MINNESOTA COMMITTEE ON UNIFORM TRAFFIC CONTROL DEVICES
JUNE 14, 2017 MEETING MINUTES
WATERS EDGE ROOM 403

2. **BUMPS/ROUGH ROAD Signs**.....Ken Johnson

3. **6F.50.2 One-Direction Large Arrow Sign (W1-6)**Ken Johnson

TYPICAL BUMP SIGNING

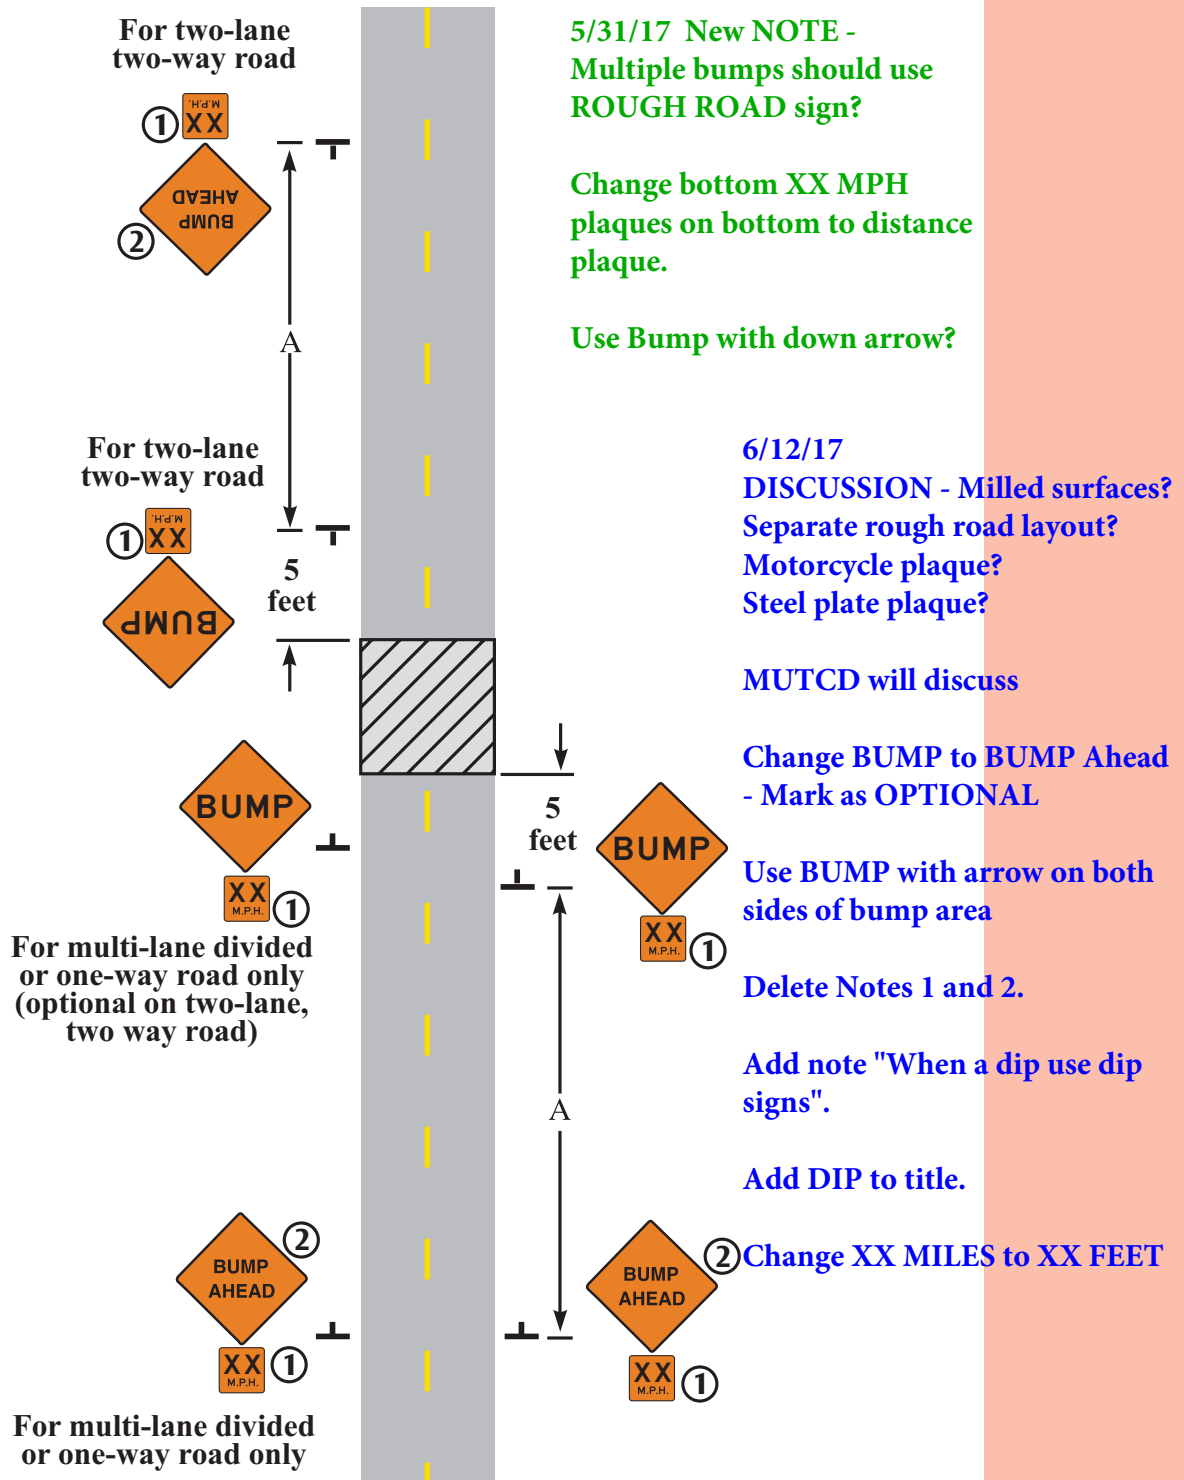
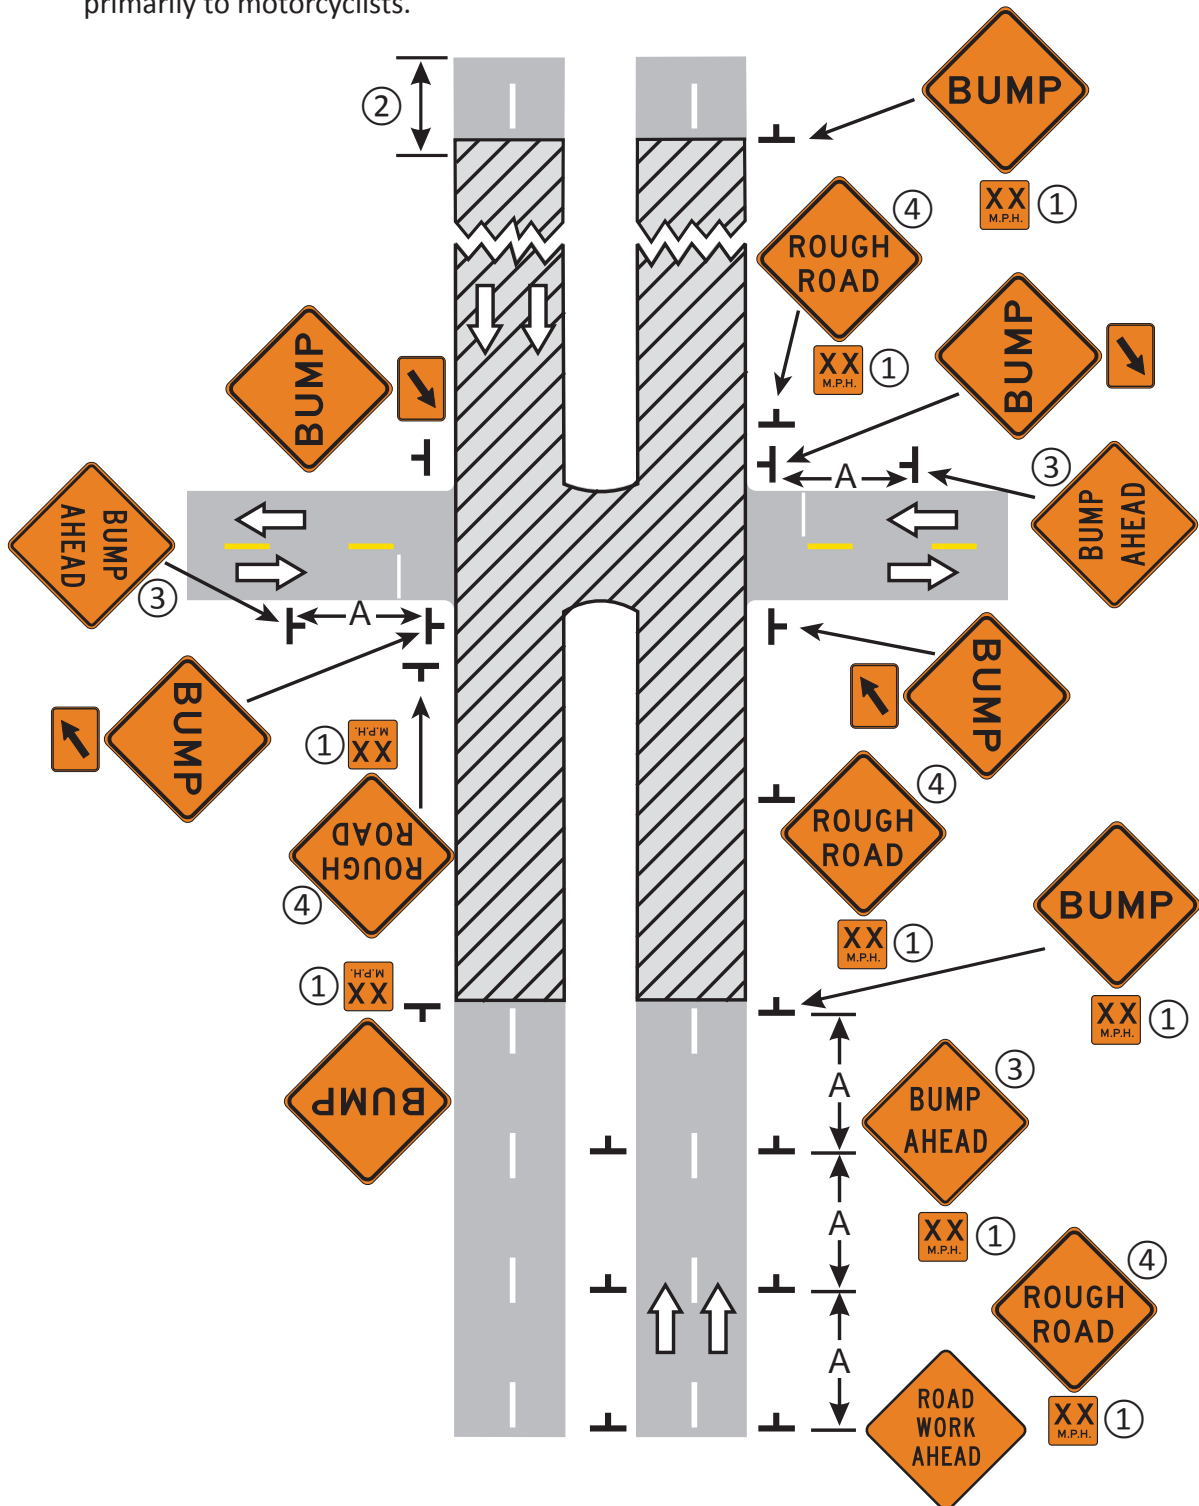
Field Manual does not match the MN MUTCD description on how to use signs.

Should advance warning signs be optional (depending on severity of bump)?

How important is the advisory speed plaque?

The Field Manual committee is modifying the bump layouts to match the MN MUTCD language.

**RE-SURFACING OPERATION
WORK SPACE BEFORE AND THRU INTERSECTION
MULTI-LANE DIVIDED ROAD**

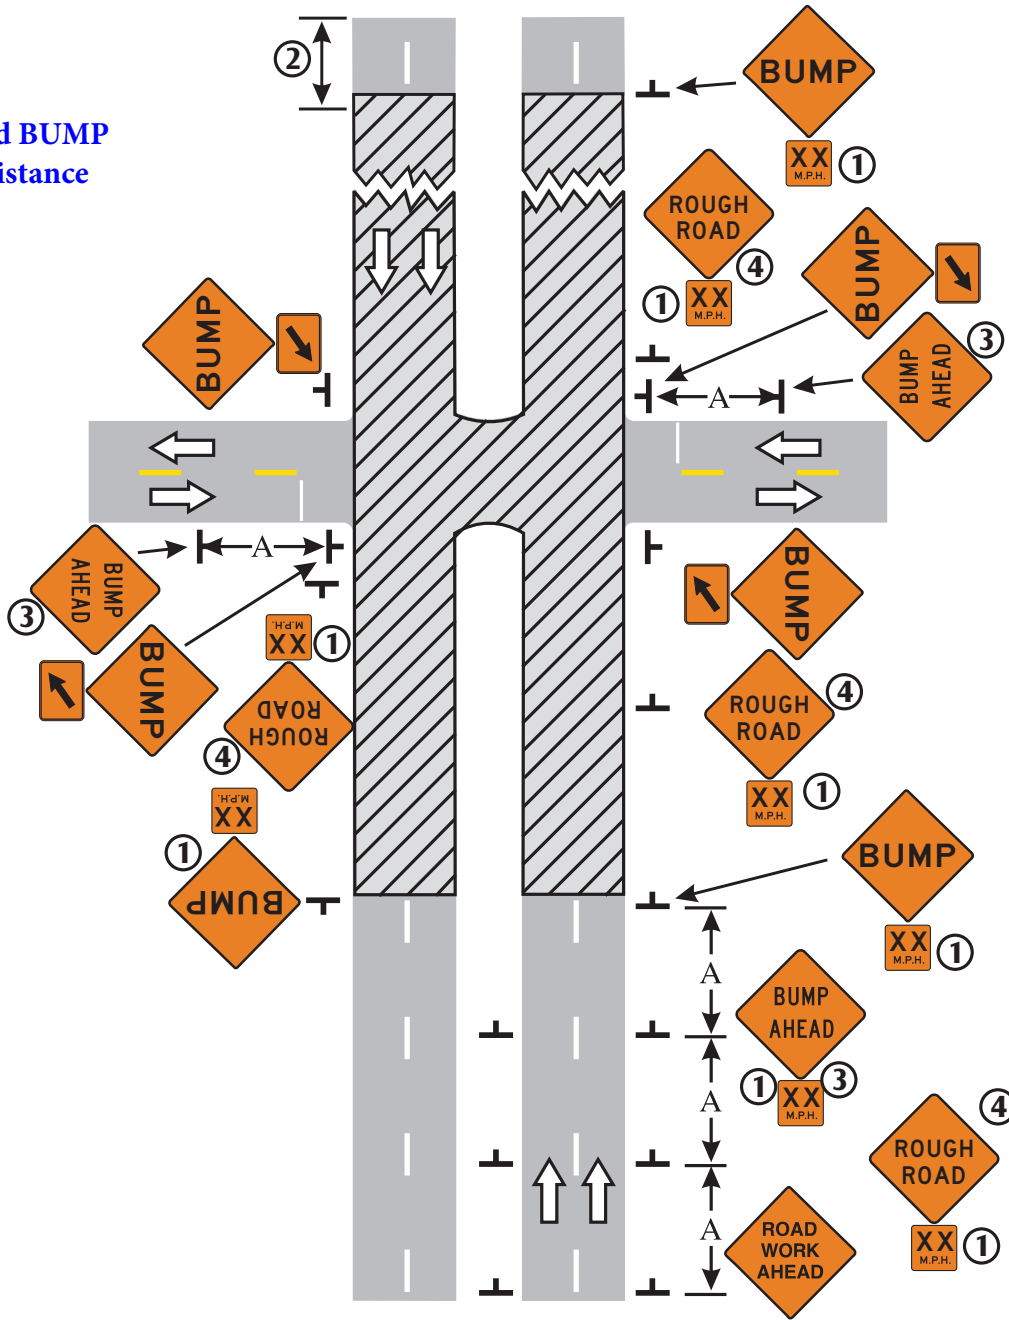
Sign clutter

Do we need all the signs? Especially the Rough Road signs together with Bump Ahead signs?

Should replace the XX MPH plaques with down arrows at bump location.

Discuss - Should BUMP AHEAD have distance plaques?

Action: The Field Manual committee will discuss further. Tabled for another meeting.
